STN 50-470F

December 5, 1984
LD-84-071

Subject: High Pressure Safety Injection Flow

FIGURE 1
0.05 FT² BREAK - REDUCED HPSI PUMP DELIVERY
PEAK CLAD TEMPERATURE

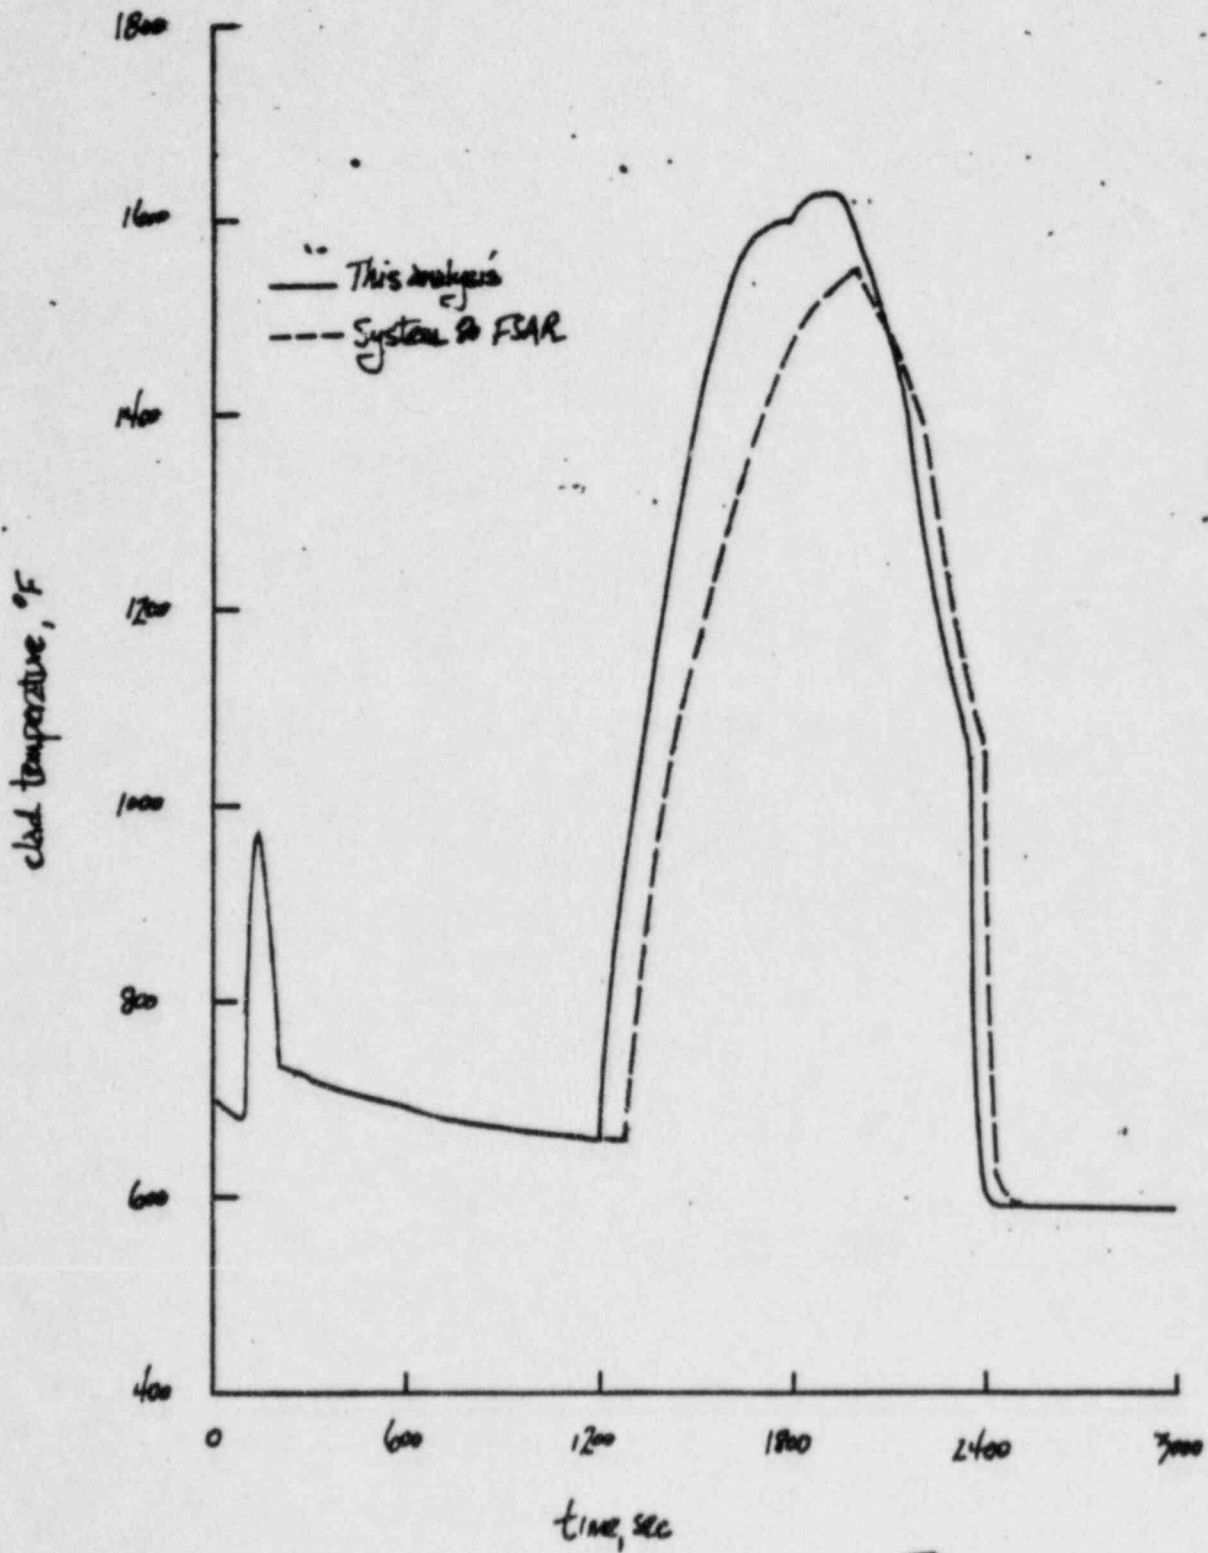
A comparison of the previous peak clad temperature and two-phase mixture height in the core is attached (Figures 1 and 2). Also attached is a CESSAR change that is provided for your review. It will be incorporated into CESSAR in the next amendment.

A review of Figures 1 and 2 indicates that the maximum peak clad temperature for this break size increased from 1557°F (from previous CESSAR analyses) to 1630°F. This increase is attributed to the slightly longer period of core uncover resulting from the decrease in HPSI flow delivered. This small break analysis is still conservatively bounded by the most limiting large break LOCA peak clad temperature (2169°F occurs in a 1.0 ft² double-ended cold leg guillotine break).

The .05 ft² case yeilds a peak clad temperature of 1557°F based on the SI pump flow capacities of Table 6.3.3.3-1 and 1630°F based on the SI pump flow capacities of Table 6.3.3.3-1A. In either case the result is more than 500°F higher than the other small break cases presented yet more than 500°F below the limiting large breaks reported in Section 6.3.3.1.
